CONSOLIDATED EDISON COMPANY
OF NEW YORK, INC.

(Indian Point Station, Unit No. 2)

Evaluation of Modifications
to
Steam Generator Support Shoes
and
Reactor Vessel Support Ring
at
Indian Point Generating Station
Unit No. 2

ATTACHMENT No. 1
to Report DC-96
May 5, 1972

MODIFICATION #2 (PAGES 6 & 7) BASE PLATE CUTBACK

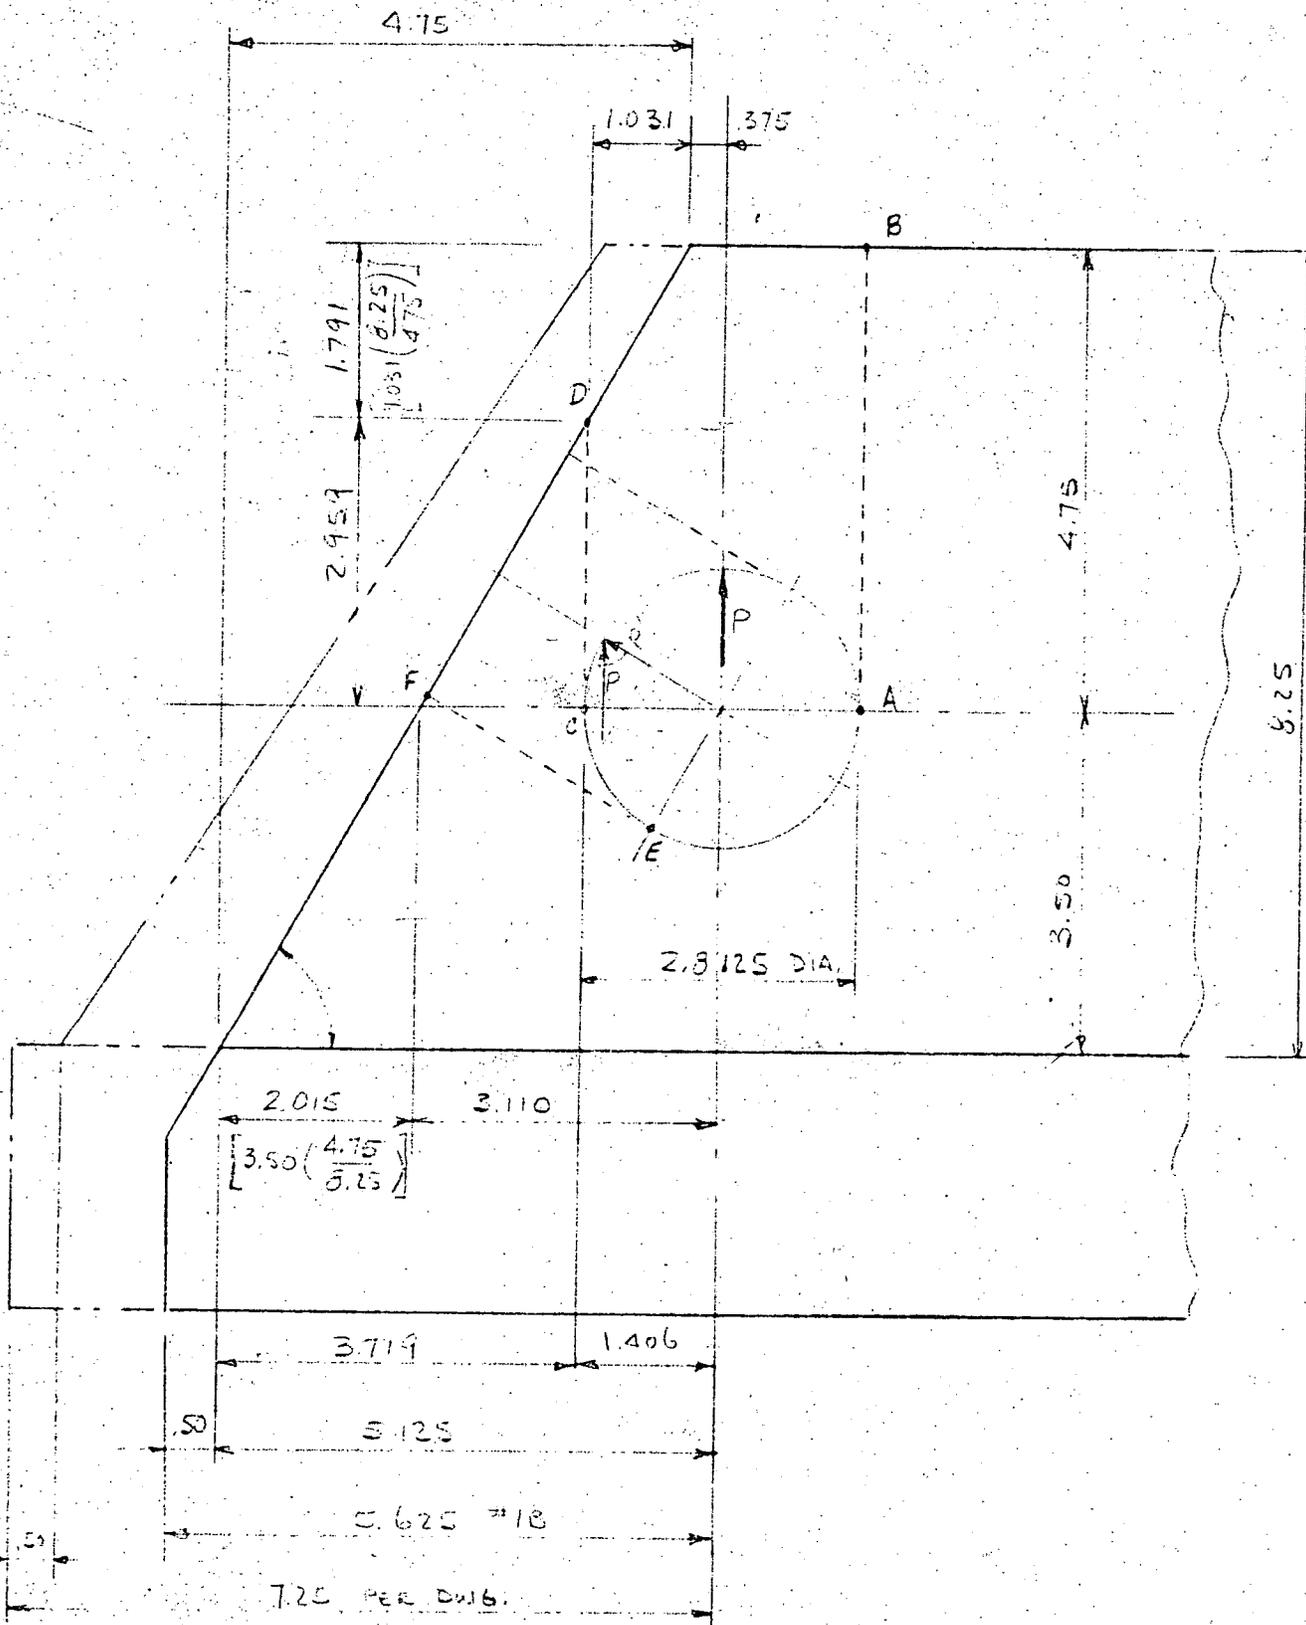
WELD AREA, AS CUT-BACK, EXCEEDS MIN. GUSSET CROSS-SECTIONAL AREA THROUGH PINHOLE, AND SO IS NOT LIMITING. CONSERVATIVELY CALCULATED STRESS AT MIN. AREA TRU PINHOLE IS $33297 \text{ PSI} < S_{\text{allow}} = 0.45F_y = 40000 \text{ PSI}$.

OTHER BASE PLATE CUT-BACKS ARE CORNER & EDGE MITRES OF NON-LOAD-CARRYING MATERIAL.

MODIFICATION #2 - CORNER BEVELS ON BASE PLATE

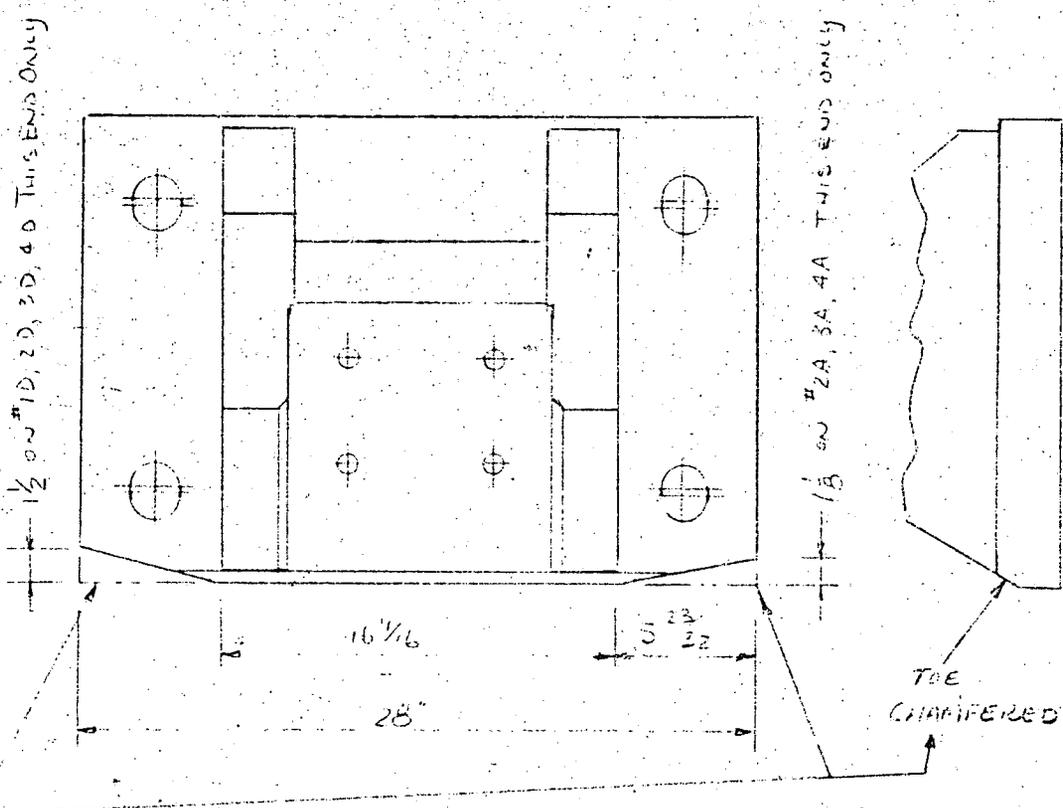
MATERIAL REMOVED HERE AT THE CORNERS IS NON-LOAD CARRYING MATERIAL. STRENGTH OF SHEET IS UN-AFFECTED.

REF. [A.2]

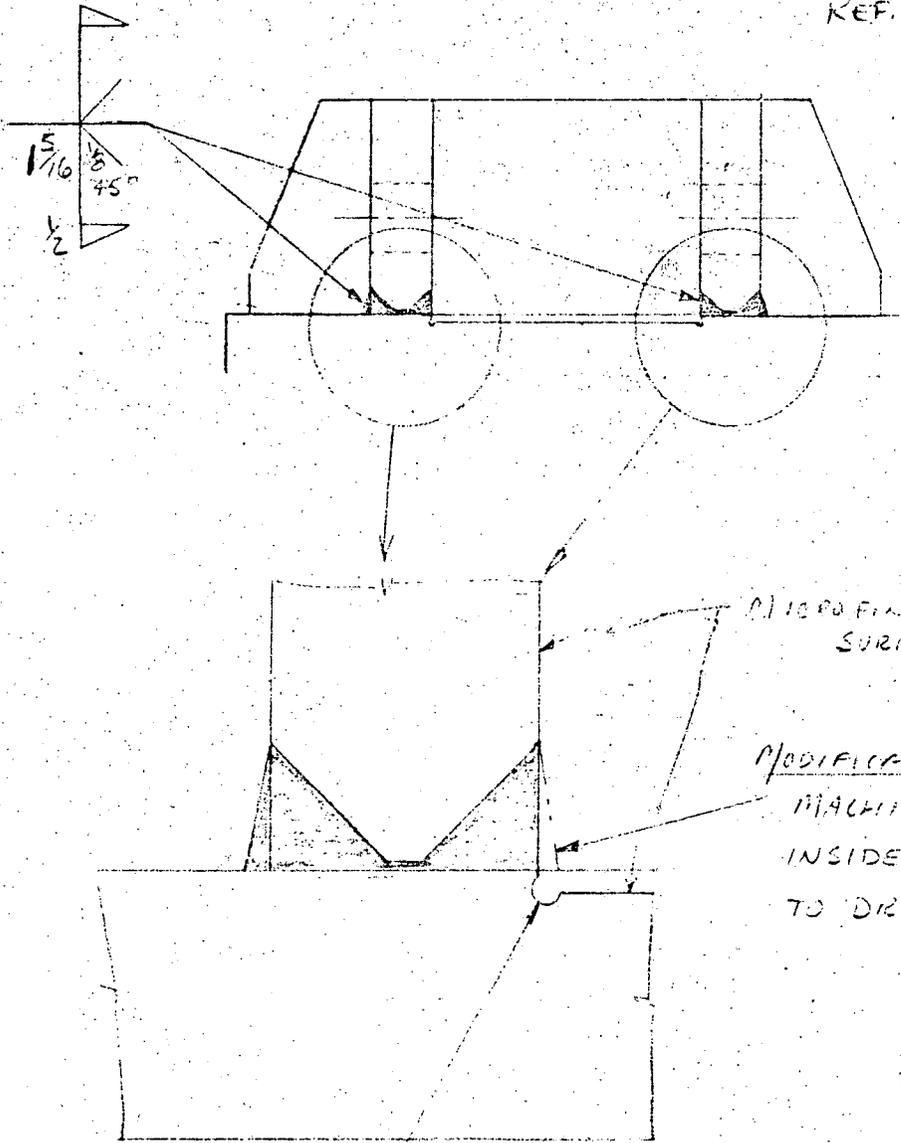
THIS MODIFICATION BRINGS THE PART TO DRAWING,
AND THEREFORE HAD NO EFFECT ON THE AS-DESIGNED
SHOE STRENGTH.

MODIFICATION #3
MACHINED TO BRING
INSIDE SURFACES
TO DRAWING.

REF DRG [B.5, C.2, A.4]

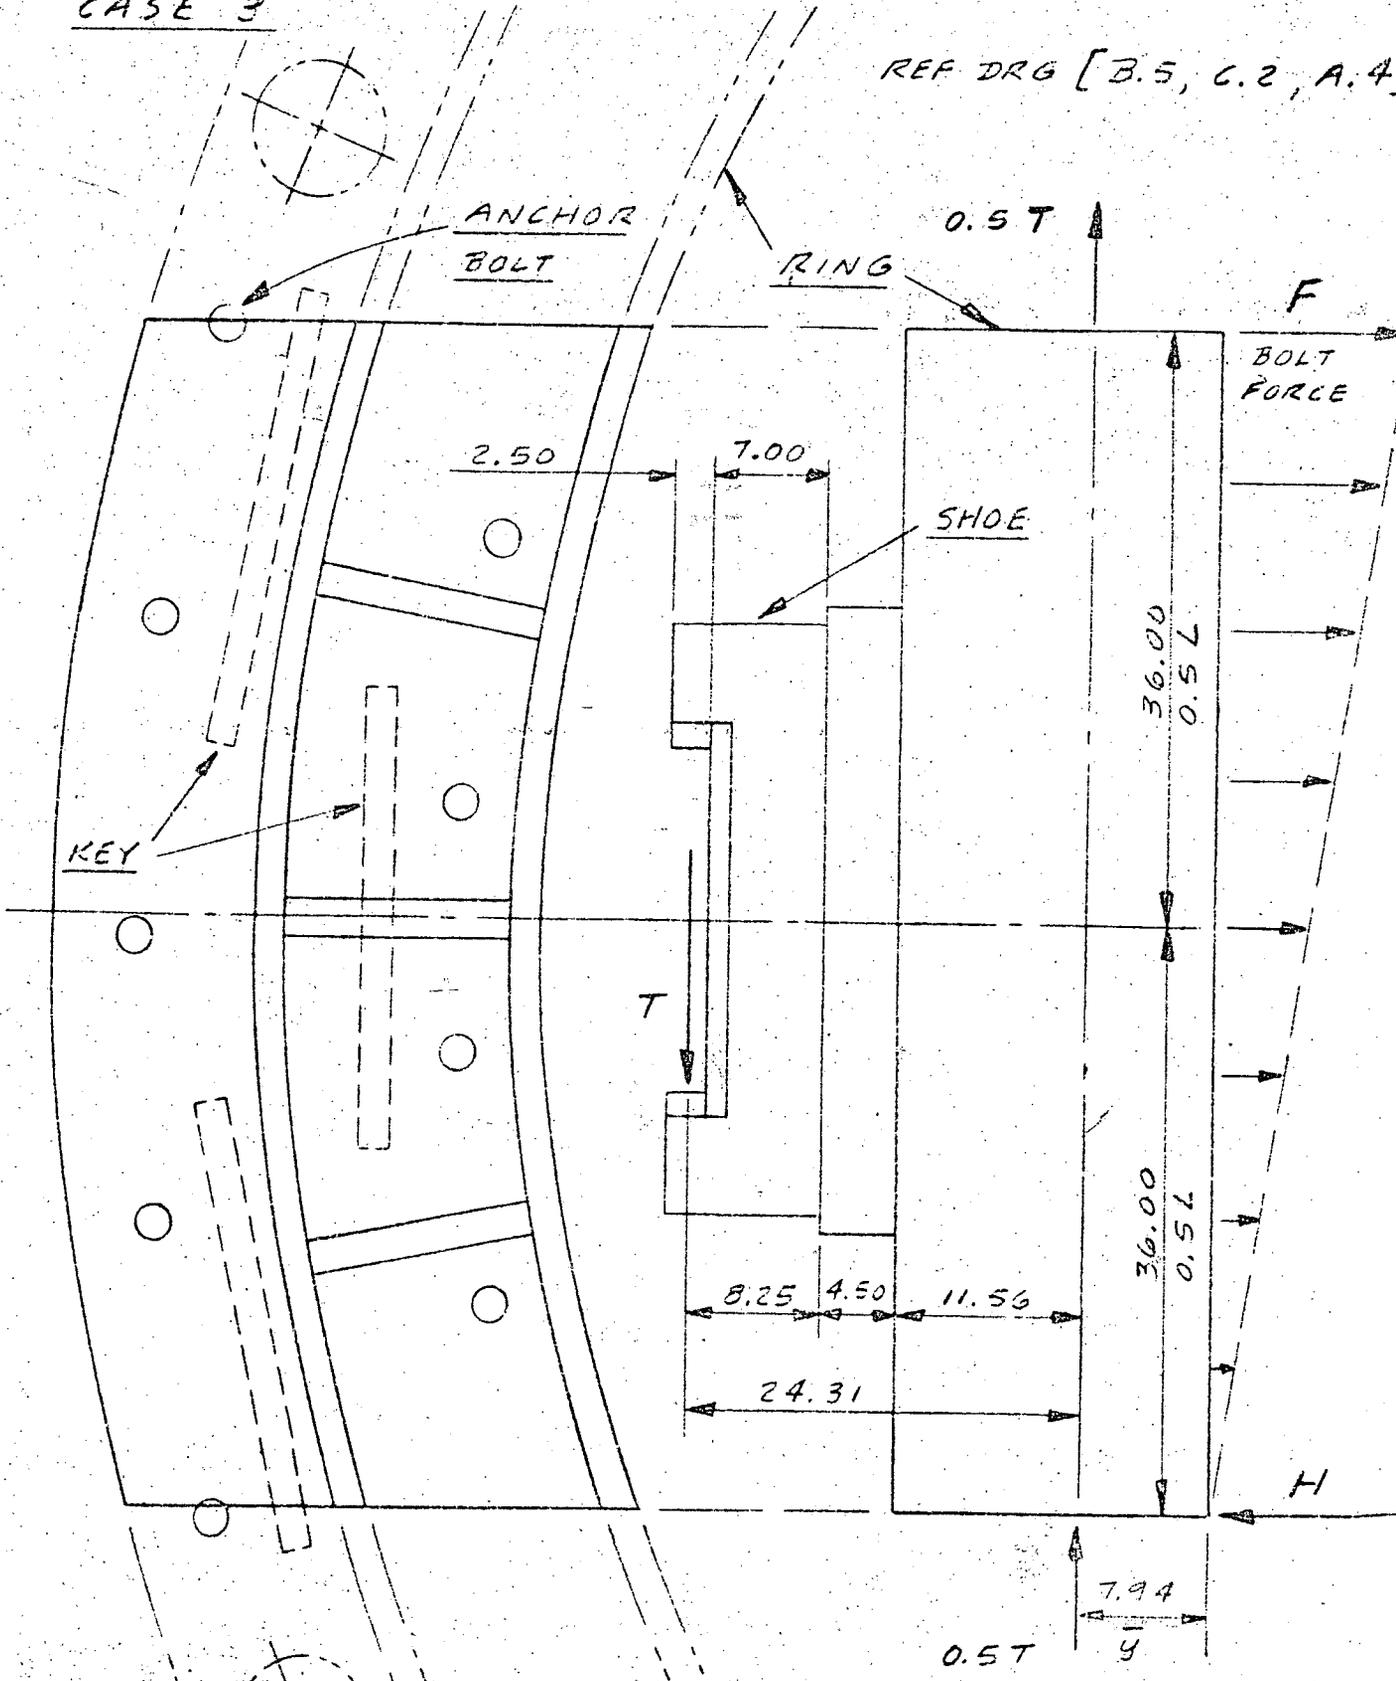
STRESSES CAUSED BY TANGENTIAL FORCE T
CASE 3

STRESS CAUSED AT TOP OF ANCHOR BOLT
ACCESS OPENINGS BY RADIAL FORCE R
AND TANGENTIAL FORCE T.

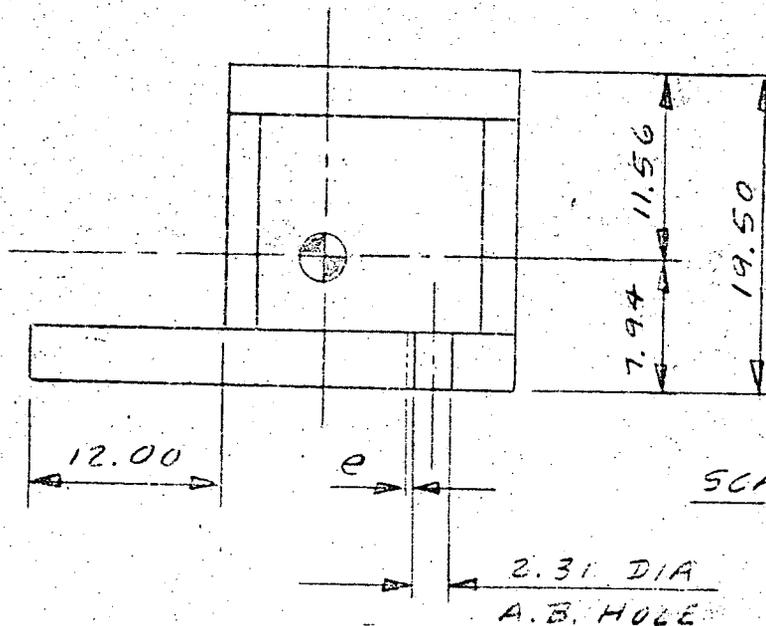
NOTE : THE FLAME CUT OPENINGS WERE MODIFIED BY DRILLING AS SHOWN.

THE 2.31 DIA HOLE IS SPECIFIED BY THE DRAWING. ELONGATION e , WHICH IS DRAWN TO SCALE, PICTORIALIZES THE WORST CONDITION.
